Access Compliance Report

Public Rights-of-Way

Intersection ID: 45242	Main Street: TALUS_TRACE_LN	Cross Street: KODIAK_CT	Location: NW
ADA ID: CC85E344B312	Ramp Type: PerpDiag	Initial Pass/Fail: Fail	Overall Compliance: No
Severity Score: 8.75			
Codes/Mitigation Info/Possible Solution		Field Measurements/Component Compliance

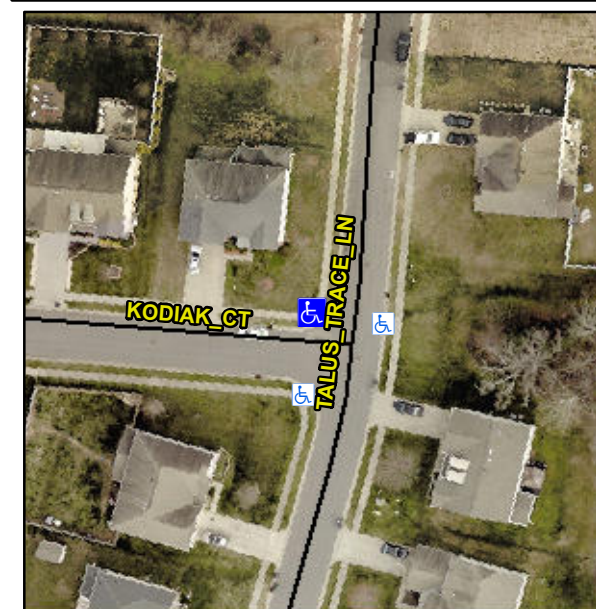
Not Found, R304.5.1

Compliance	Description	Data	Compliance	Description	Data
N/A	Ramp Length (in)	46.5	Yes	Ramp Slope (%)	5.7
No	Ramp Width (in)	47.0	Yes	Ramp XSlope (%)	1.1
N/A	Flare Type LT	N/A	N/A	Flare Type RT	N/A
N/A	Flare Slope LT (%)	N/A	N/A	Flare Slope RT (%)	N/A
N/A	Flare Traversable LT?	N/A	N/A	Flare Traversable RT?	N/A
N/A	Landing Length (in)	N/A	N/A	DWS Provided?	N/A
N/A	Landing Width (in)	N/A	N/A	DWS Contrast?	N/A
N/A	Landing Slope (%)	N/A	N/A	DWS Length (in)	N/A
N/A	Landing X Slope (%)	N/A	N/A	DWS Full Width?	N/A
N/A	Landing Curb? (Y/N)	N/A	N/A	DWS Offset (in)	N/A
N/A	Shared Landing?	N/A			
N/A	Gutter Ponding?	N/A	N/A	Gutter Slope (%)	N/A
N/A	Gutter Lip Ht (in)	0.5	N/A	Gutter X Slope (%)	N/A
N/A	Painted X Walk1?	No	N/A	Painted X Walk2?	No
	X Walk 1 Direction	To S		X Walk 2 Direction	To E
N/A	X Walk 1 Width (in)	N/A	N/A	X Walk 2 Width (in)	N/A
	X Walk 1 Slope (%)	0.5		X Walk 2 Slope (%)	2.0
	X Walk 1 X Slope (%)	0.1		X Walk 2 X Slope (%)	0.7

Remove & Replace Curb Ramp With Two New Directional Ramps or Equivalent.
